- Remedial Works which Require Attention Prior To The Development Being Considered For Adoption.**

SCALE WHEN PLOTTED AT 1:500			DRAWING STATUS PRELIMINARY	
DRAWN RH	CHECKED CH	DATE 05.09.18	DRAWING NUMBER 42937/021	REV C

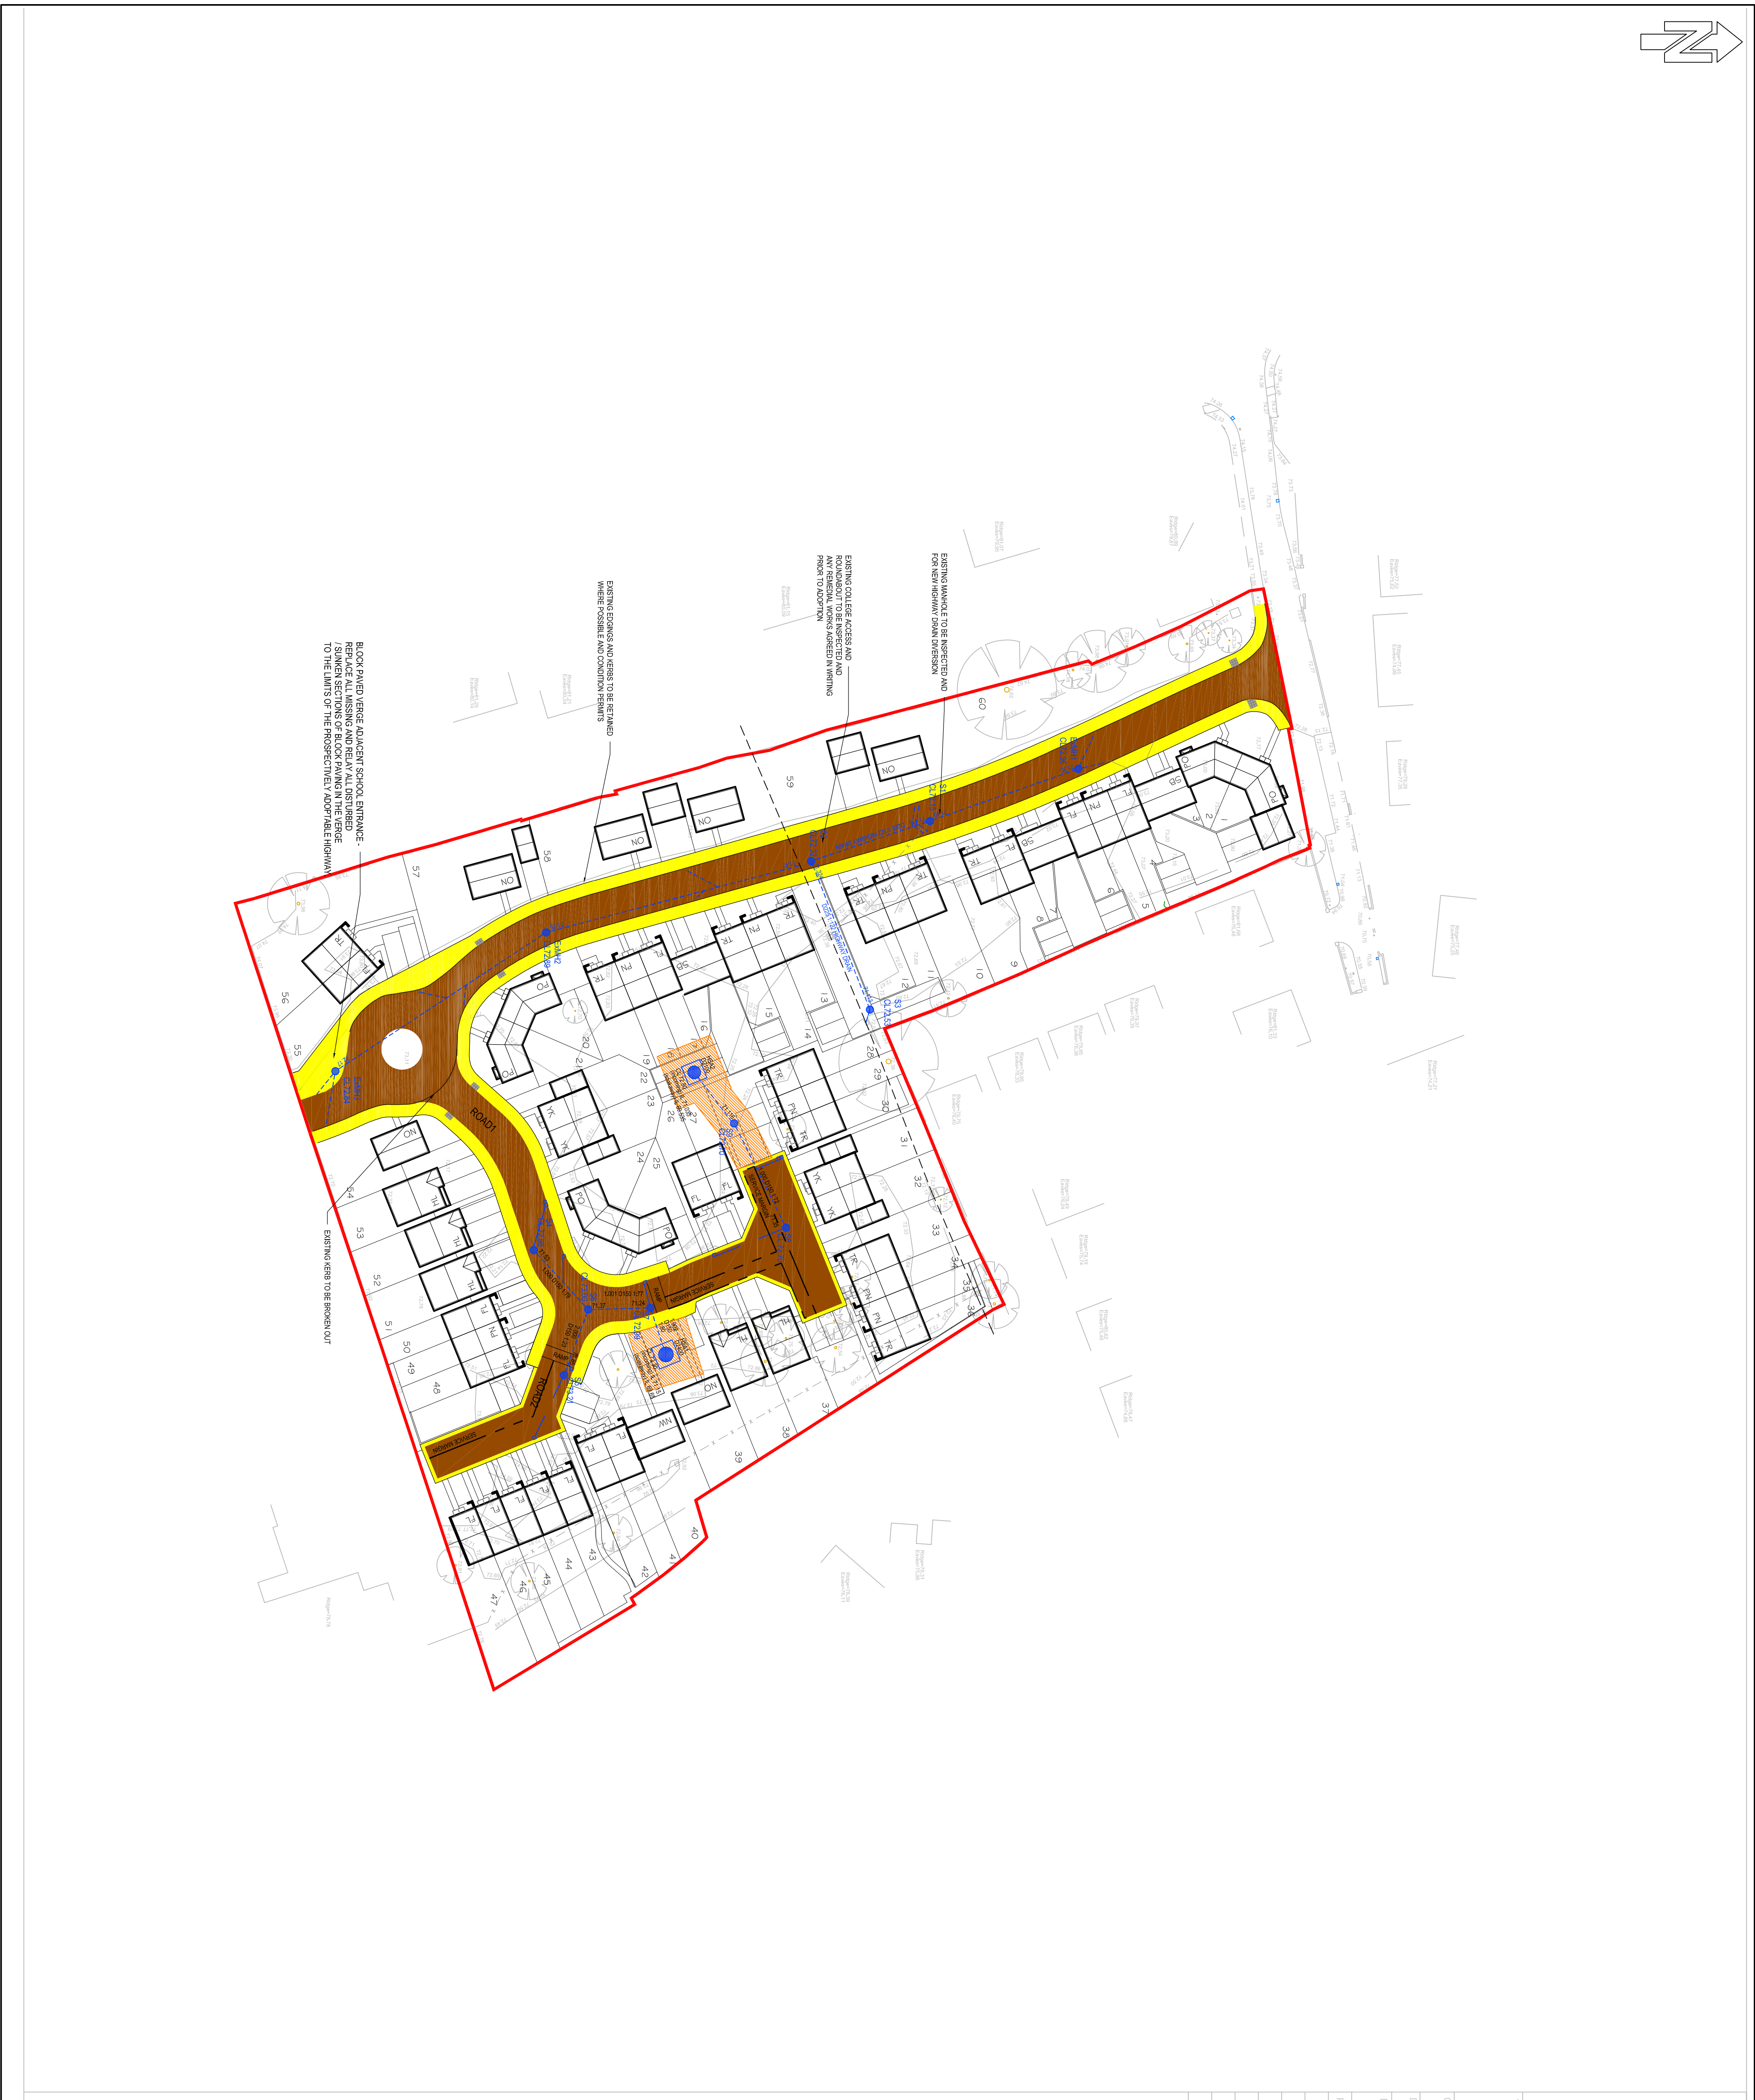
- Reattach while lying to the junction.
- Repair / Replace damaged vents on left hand drains.
- Realign lamp column / Inlo and which is prospectively adoptable highway.

- Grub out and treat weed growth accordingly.
- Cut back all overhanging vegetation.
- Clean out all gully pots and bench drybricks as necessary. Please note there are some large pieces of concrete and other large debris in the gullies which should be removed.

- Forwarders in partnership - Reseal the pavements (SN) within the carriageway to the correct line and level and on completion reconstruct the carriageway to their parameters (minimum patch 500mm to all sides).

- There appears to have been some standing water along the left hand channel line. In the presence of the Ice Francis perform a water test on the channel lines to determine if water disperses to the gullies.

- Left hand radius vents on approach to the roundabout - Replace the damaged vents and relay the vents which have been knocked out of line. On completion make good any disturbed surfaces.

- Block drains using different sized entrance - Replace all missing and relay all damaged / surface drains of block paving in the verge to the limits of the prospectively adoptable highway.

- Lamp column in right hand roadway on approach to the roundabout - Fit missing column to define the line of the lamp column to define the limits of the prospectively adoptable highway

- Provide a copy of the Yorkshire Water Vetting certificate confirming the sewers have been adopted.
